City of Columbia

Municipal Planning Commission

December 8, 2021

RE: Response to Technical Review Comments
Item No. 21-0205
1451 Lasea Road
Preliminary PUD Master Plan

FIGURE 6-TRAFFIC IMPACT STUDY

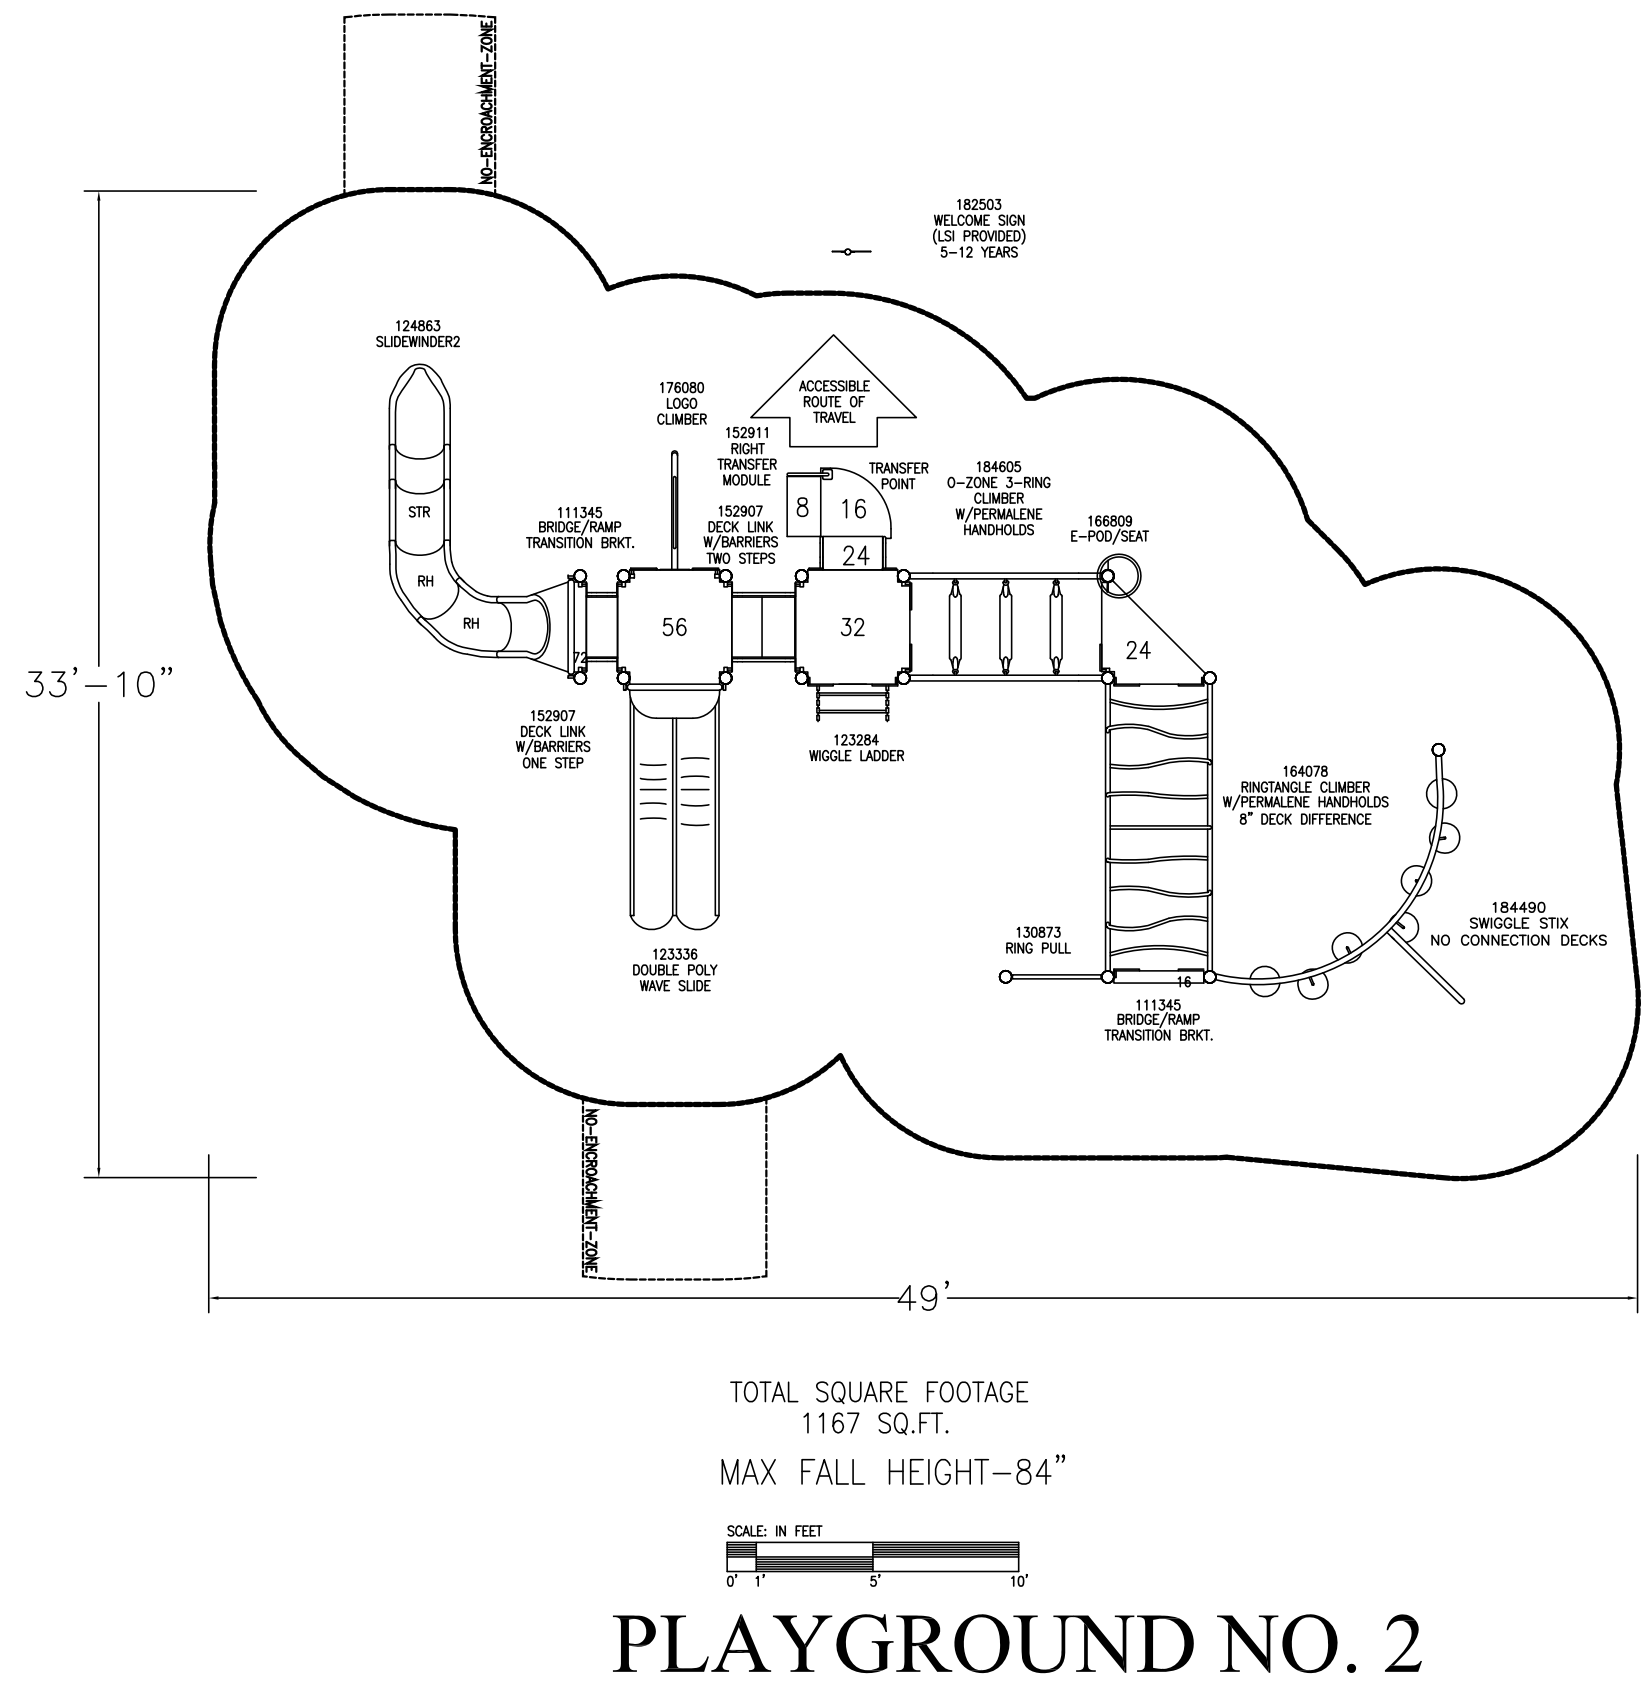
12. Subject to TIS and Construction Plans.
13. Provide figure 6 from TIS in PUD resubmittal.
14. Should any of the background developments fail to be constructed, including the off-site improvements, by the time the Lasea Townhomes are completed, the developer of the Lasea Townhomes should re-assess the off-site improvements and may be responsible for the construction of those improvements, if necessary.

12. Subject to TIS and Construction Plans. Ok
13. Provide figure 6 from TIS in PUD resubmittal. Added to detail sheet
14. Should any of the background developments fail to be constructed, including the off-site improvements, by the time the Lasea Townhomes are completed, the developer of the
